Planning reference: 3/2024/0996

Location : 98 Ribchester Road and land adjacent 94 Ribchester Road, Clayton-Le-Dale, BB1 9HQ

Proposal : Approval of details reserved by conditions 9 (SW drainage), 12 (drainage scheme)

EXISTING DRAINAGE

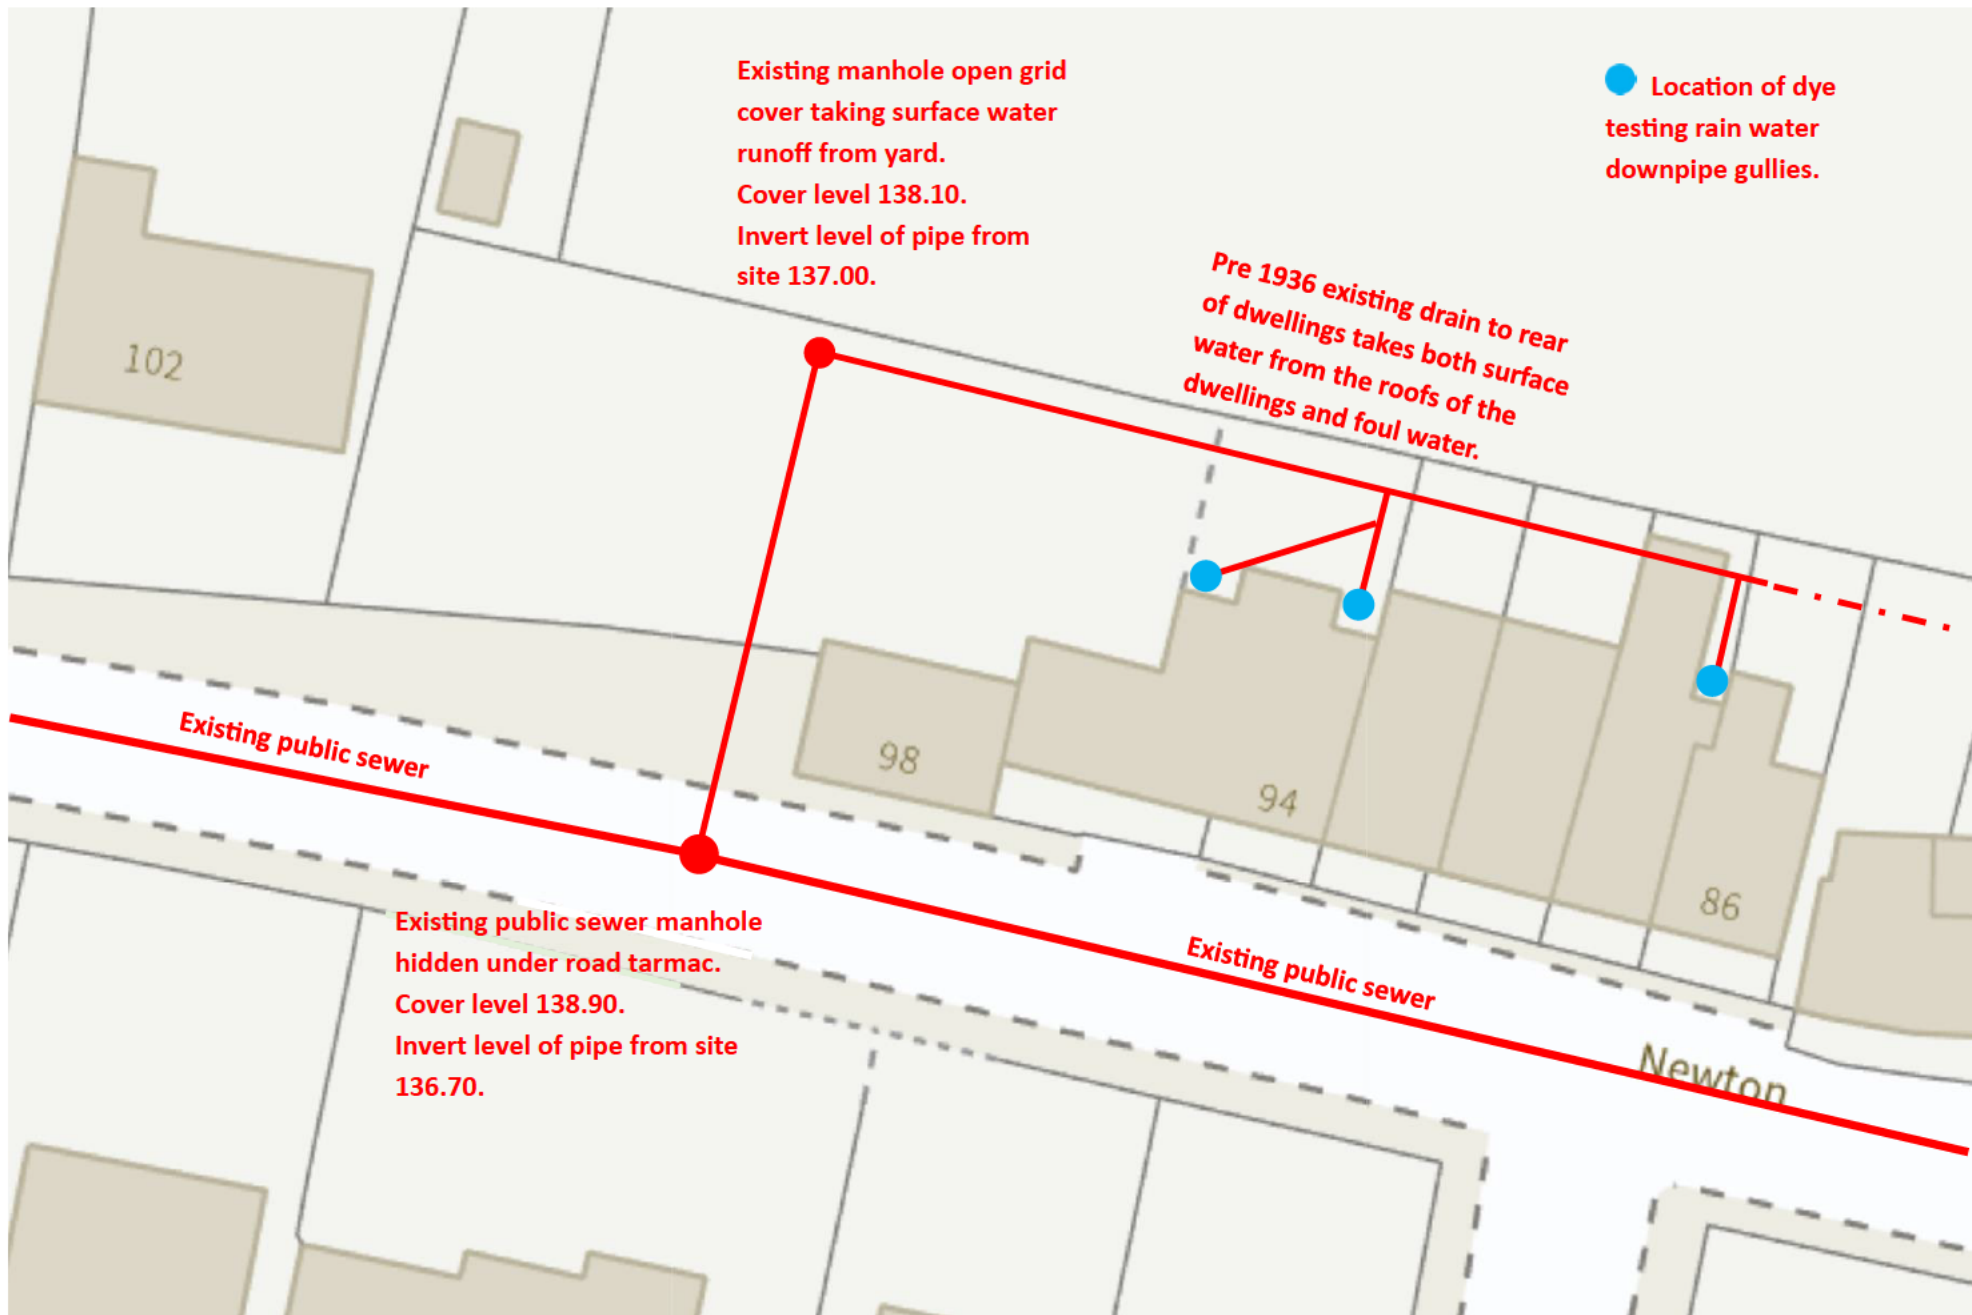
2. The sewer shown on our records is being assumed to be a combined sewer. The asset maps indicate it is a foul only sewer. We require evidence i.e. a drainage survey, to confirm that the foul sewer we have on our records is in fact a public combined sewer.

Response: A drainage survey has been carried out of the drainage within and beyond the application site. The result of the survey is shown on the existing drainage plan attached to this letter.

The drainage within the site extends beyond the site to the east of the site and serves the properties to the east that front onto the northern side of Ribchester Road. Dye testing has been carried out on the gullies taking rainwater from the roofs to the rear of the properties and it has been proved that the drain running along the rear of the existing properties takes both surface and foul water from the existing properties.

As stated above in response to item 1 above, it has been proved that this drain, leaving the development site under the existing access, is connected to the public sewer that lies within Ribchester Road into an existing manhole that is hidden under the road surfacing. As such, the public sewer within Ribchester Road is actually a combined sewer as it is taking both surface water and foul water from the existing properties that lie along the northern side of Ribchester Road. Therefore, under the hierarchy for dealing with surface water runoff from development sites, it is acceptable for surface water runoff to be discharged into it.
